SUBJECT: ISSUANCE OF AMENDMENT NOS. 188, 188 AND 185 TO FACILITY OPERATING  
LICENSES DPR-38, DPR-47 AND DPR-55 - OCONEE NUCLEAR STATION,  
UNITS 1, 2 AND 3 (TACS 75344, 75345, 75346)

The amendments revise the Pressure/Temperature Limits and the Low Temperature  
Overpressure Protection system operability requirements in Section 3.1 of the  
TSs and revise the associated bases.

SAFETY-EVALUATION-BY-THE-OFFICE-OF-NUCLEAR-REACTOR-REGULATION  
RELATED-TO-AMENDMENT-NO.-188-TO-FACILITY-OPERATING-LICENSE-DPR-38

OCONEE-NUCLEAR-STATION,-UNITS-1,-2,-AND-3

Figure 3.1.2-2C

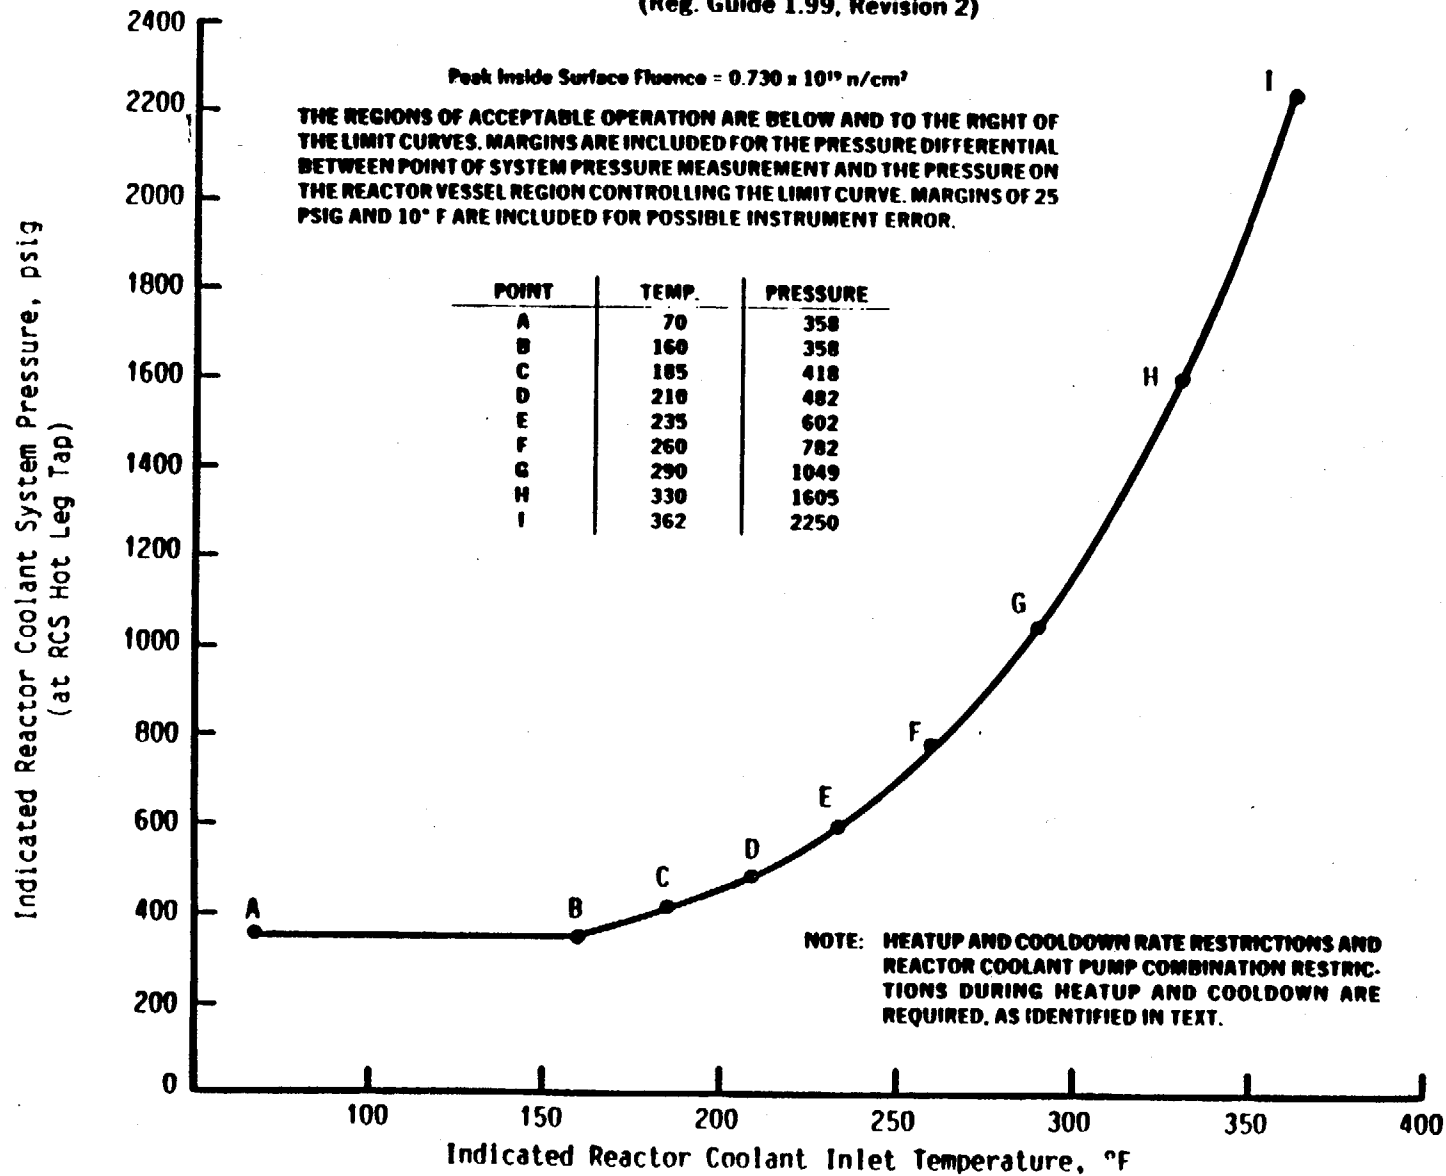
Unit 3 Oconee Nuclear Station  
Reactor Coolant System Normal Operation Cooldown  
Limitations Applicable for First 15.0 EFPY  
(Reg. Guide 1.99, Revision 2)

The changes to P/T limits are in response to Generic Letter (GL) 88-11, "NRC Position on Radiation Embrittlement of Reactor Vessel Materials and Its Effect On Plant Operation." The current P/T limit curves are based on an assumed design basis neutron fluence through 15 effective full power years (EFPYs). The proposed P/T limit curves were developed based on the guidance of Regulatory Guide (RG) 1.99, Rev. 2, "NRC Position on Radiation Embrittlement of Reactor Vessel Materials and Its Impact on Plant Operations," and they are applicable for a period of up to 15 EFPYs. Prompted by the P/T Limit revisions, changes to the low temperature overpressure protection (LTOP) system requirements (TS 3.1.9.2) have been proposed to assure proper protection to the reactor vessel.

The licensee selected welds WF-67 and WF-70 as the limiting materials at the 1/4T and 3/4T locations, respectively, and calculated the ARTs of 195°F at 1/4T and 171°F at 3/4T. The difference between the staff's ART and the licensee's ART at the 1/4T location (202°F vs. 195°F) is because the licensee used a lower chemistry factor in the ART calculation. Substituting the ARTs of 202.2°F and 171°F into equations in SRP 5.3.2, the staff verified that the proposed P/T limits for heatup, cooldown, and hydrotest meet the beltline material requirements in Appendix G of 10 CFR Part 50. The licensee's P/T limits have sufficient safety margin such that with a lower ART the limits satisfy the Appendix G calculation.

Figure 3.1.2-3A

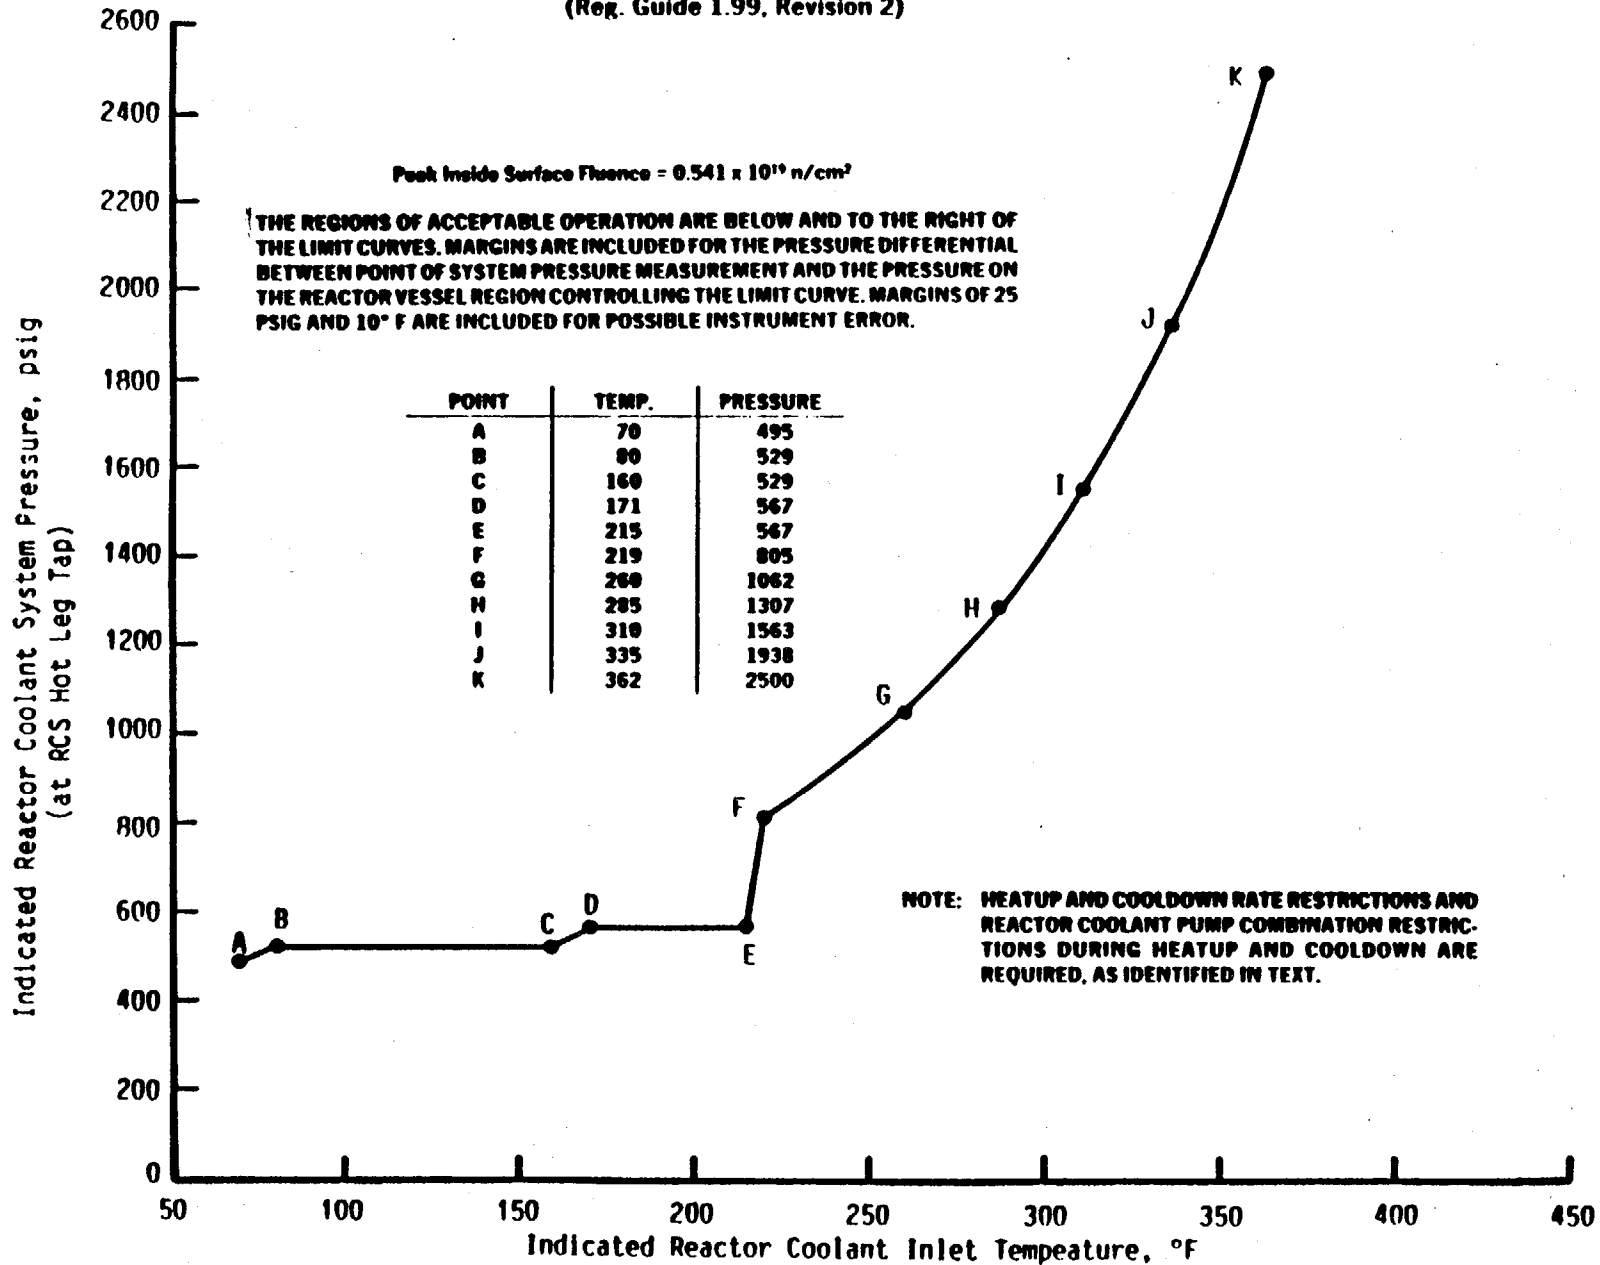
Unit 1 Oconee Nuclear Station  
Reactor Coolant System Inservice Leak and Hydrostatic Test  
Heatup and Cooldown Limitation Applicable for First 15.0 EFPY  
(Reg. Guide 1.99, Revision 2)

The licensee calculated the ARTs of  $184^{\circ}\text{F}$  and  $140^{\circ}\text{F}$  at  $1/4T$  and  $3/4T$ , respectively. Substituting the ARTs of  $184^{\circ}\text{F}$  and  $140^{\circ}\text{F}$  into equations in SRP 5.3.2, the staff verified that the proposed P/T limits for heatup, cooldown, and hydrotest meet the beltline material requirements in Appendix G of 10 CFR Part 50.

Figure 3.1.2-3B

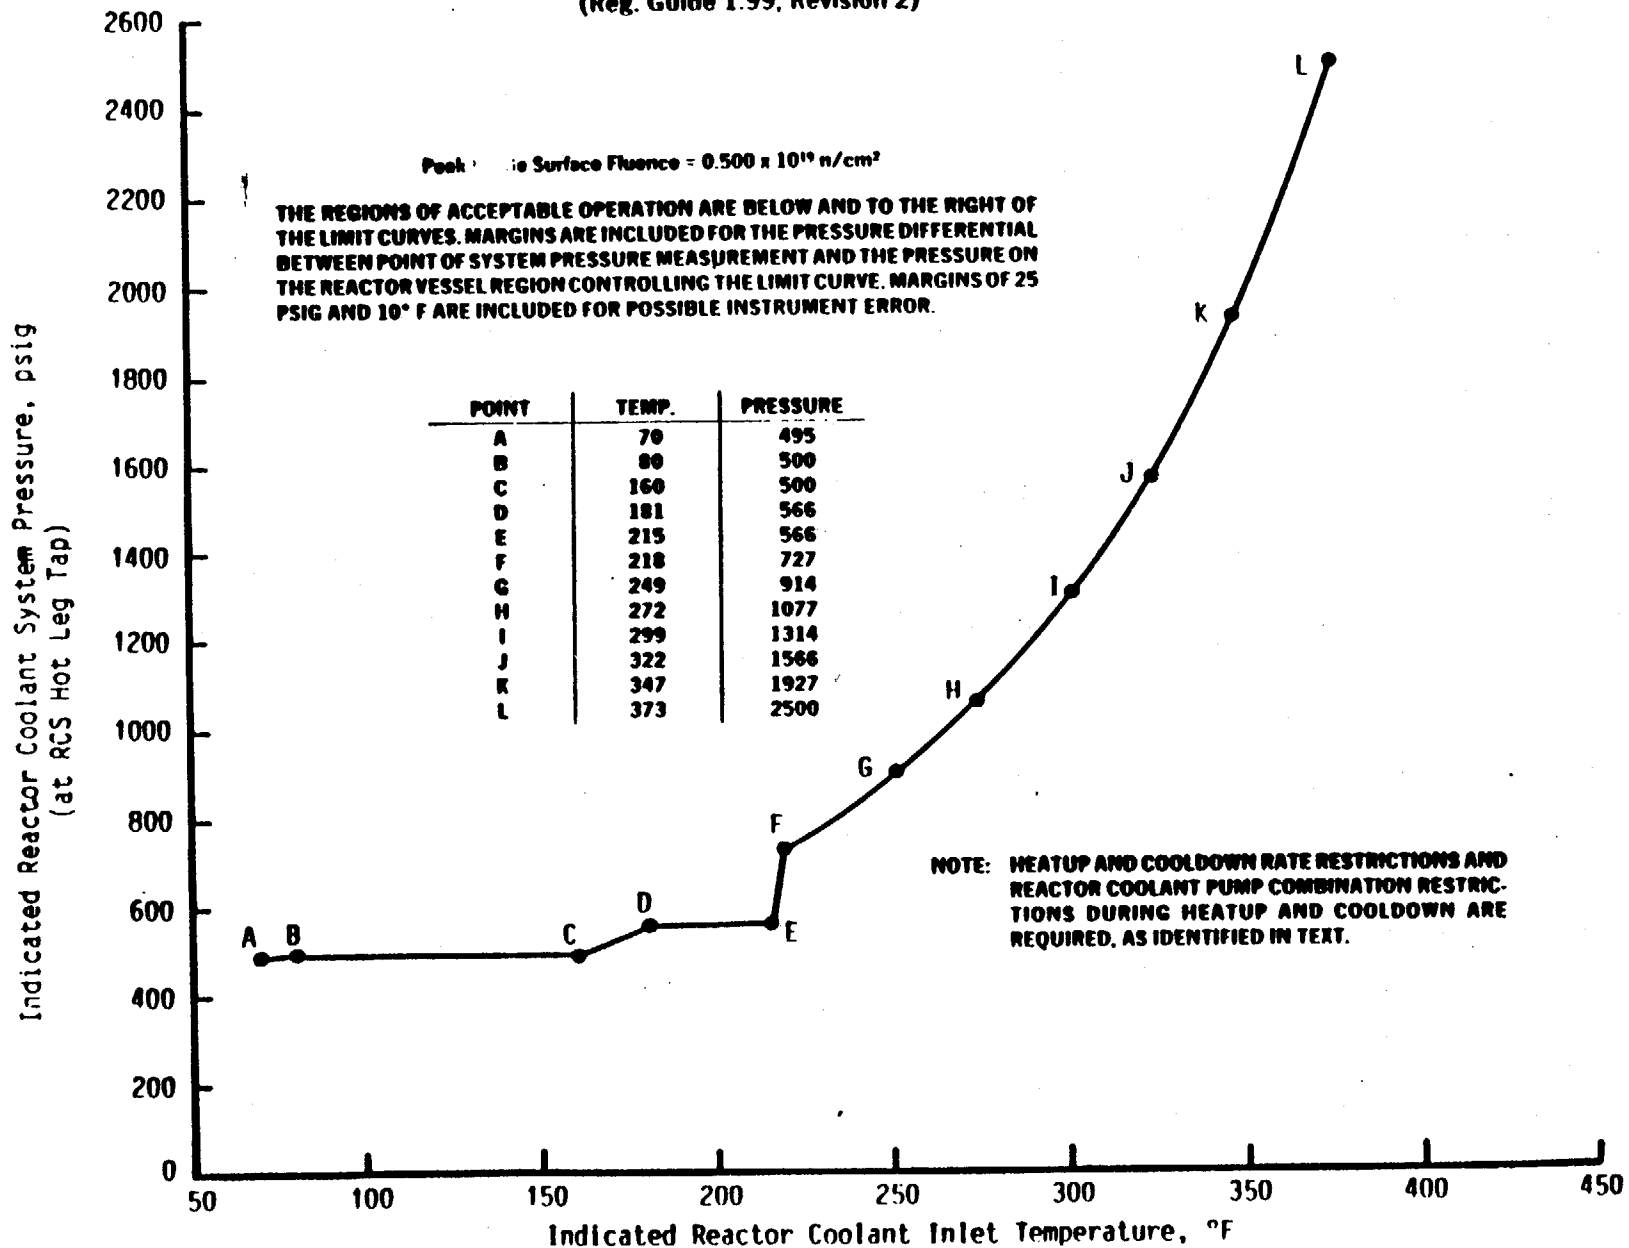
Unit 2 Oconee Nuclear Station  
Reactor Coolant System Inservice Leak and Hydrostatic  
Test Heatup and Cooldown Limitations Applicable for 15.0 EFY  
(Reg. Guide 1.99, Revision 2)

The licensee selected the weld, WF-25, as the limiting material and calculated the ARTs of 193°F and 139°F at 1/4T and 3/4T, respectively. The licensee's ARTs are conservative; therefore, they are acceptable. Substituting the ARTs of 193°F and 139°F into equations in SRP 5.3.2, the staff verified that the proposed P/T limits for heatup, cooldown, and hydrotest meet the beltline material requirements in Appendix G of 10 CFR Part 50.

Figure 3.1.2-3C

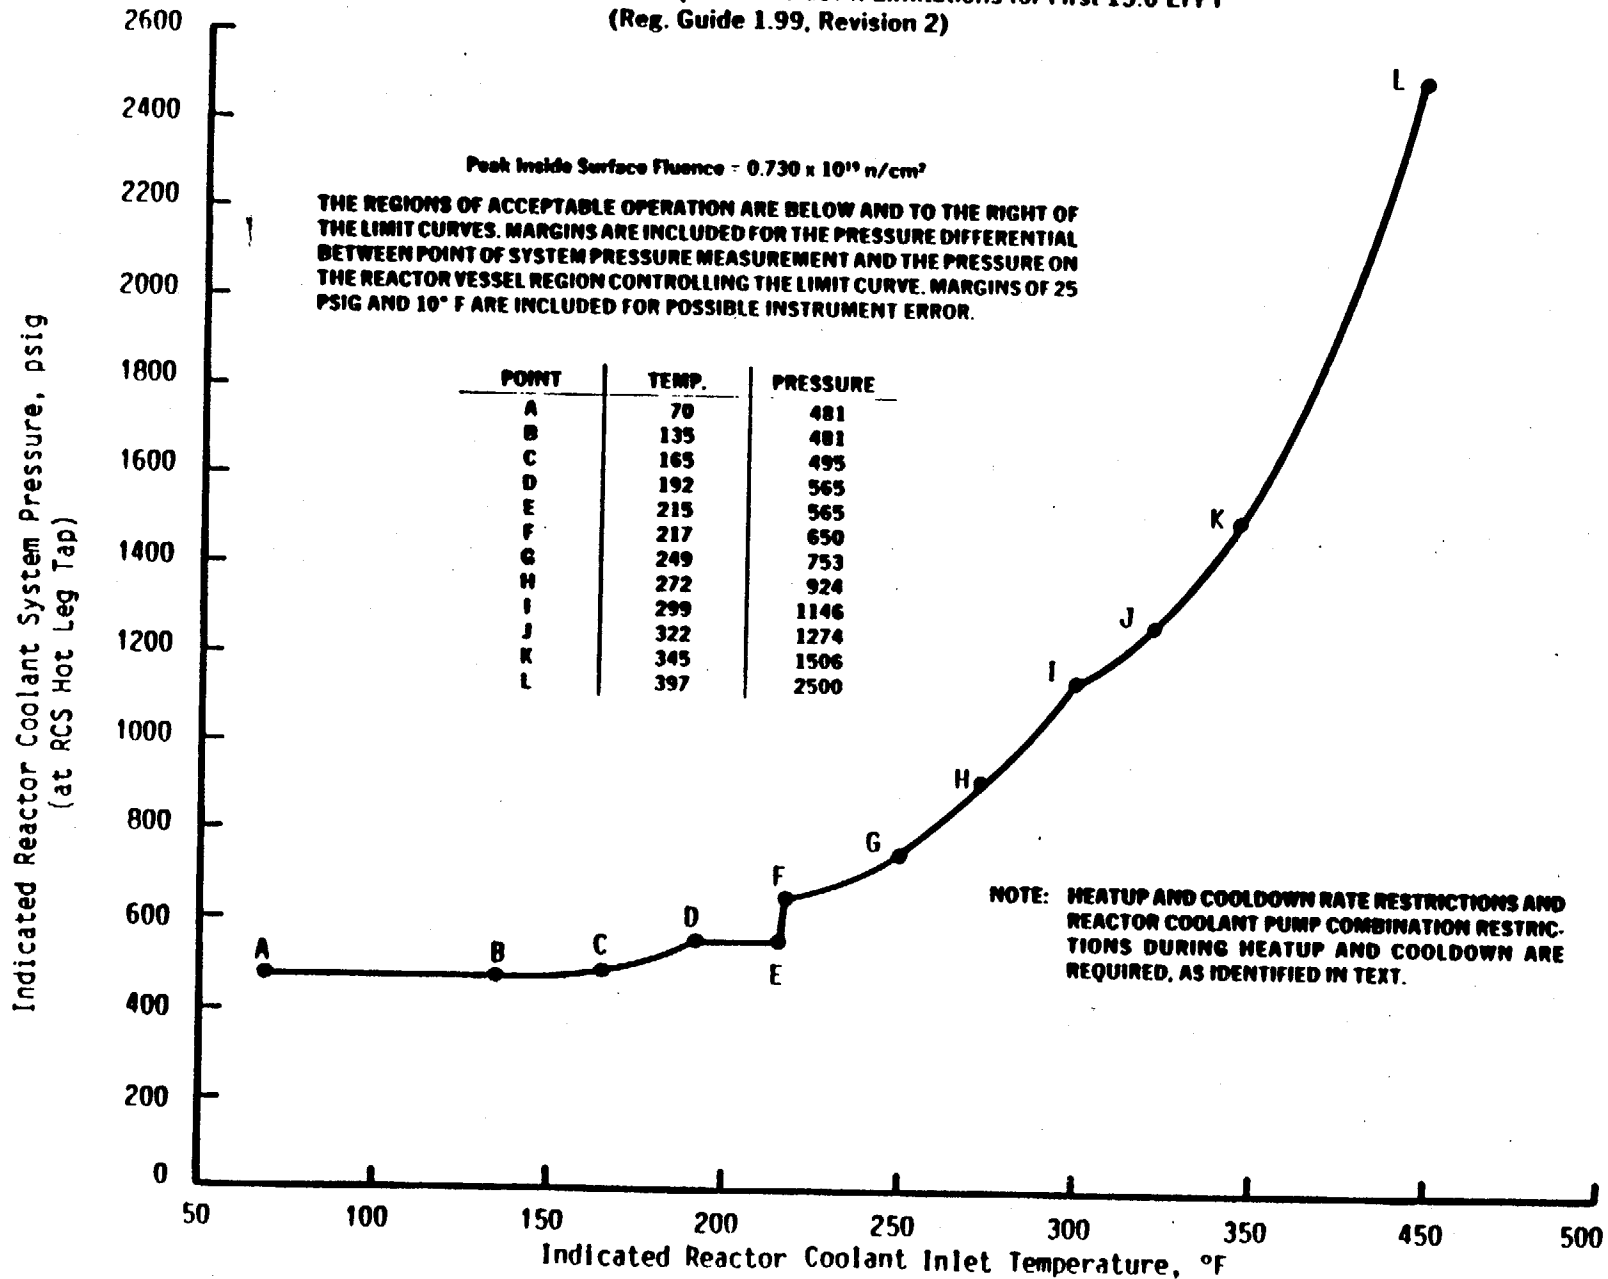
Unit 3 Oconee Nuclear Station  
Reactor Coolant System Inservice Leak and Hydrostatic Test  
Heatup and Cooldown Limitations for First 15.0 EFPY  
(Reg. Guide 1.99, Revision 2)
